Access Compliance Report Public Rights-of-Way (Curb Ramps)

Main Street: RANDALL_ST Cross Street: N_MUSTANG_AVE Location: NW

ADA ID: RPRK211222113642 Ramp Type: Type 4 - Parallel Initial Pass/Fail: Fail Overall Compliance: No Severity Score: 30

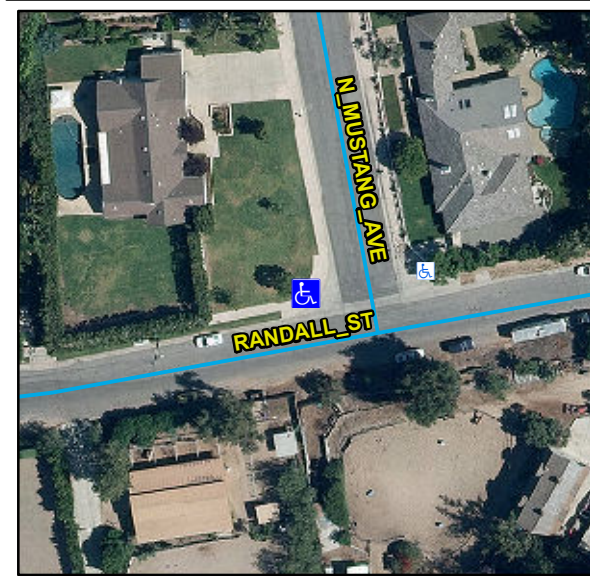
Compliance	Description	Data	Compliance	Description	Data
N/A	Ramp Length LT (in)	150	N/A	Ramp Length RT (in)	91
Yes	Ramp Width LT (in)	102	Yes	Ramp Width RT (in)	102
No	Ramp Run Slope LT (%)	10.6	Yes	Ramp Run Slope RT (%)	0.6
Yes	Ramp Cross Slope LT (%)	2	No	Ramp Cross Slope RT (%)	6.1
N/A	Landing Present	N/A	N/A	DWS Provided	N/A
N/A	Landing Length (in)	N/A	N/A	DWS Contrast	N/A
N/A	Landing Width (in)	N/A	N/A	DWS Length (in)	N/A
N/A	Landing Run Slope (%)	N/A	N/A	DWS Full Width	N/A
N/A	Landing Cross Slope (%)	N/A		DWS Offset Type	N/A
N/A	Landing Movement Obstructed?	N/A	N/A	DWS Offset Left (in)	N/A
	Landing Movement Type	N/A	N/A	DWS Offset Right (in)	N/A
N/A	Landing Shared	N/A			
N/A	Clear Space	Yes			
N/A	Clear Space To Crosswalk (in)	N/A			
N/A	Marked Crosswalk 1	No	N/A	Marked Crosswalk 2	No
	Crossing 1 Direction	S		Crossing 2 Direction	E
	Marked Crosswalk 1 Width (in)	N/A		Marked Crosswalk 2 Width (in)	N/A

Possible Solutions:
Remove & Replace Curb Ramp With Two New Directional Ramps or Equivalent.
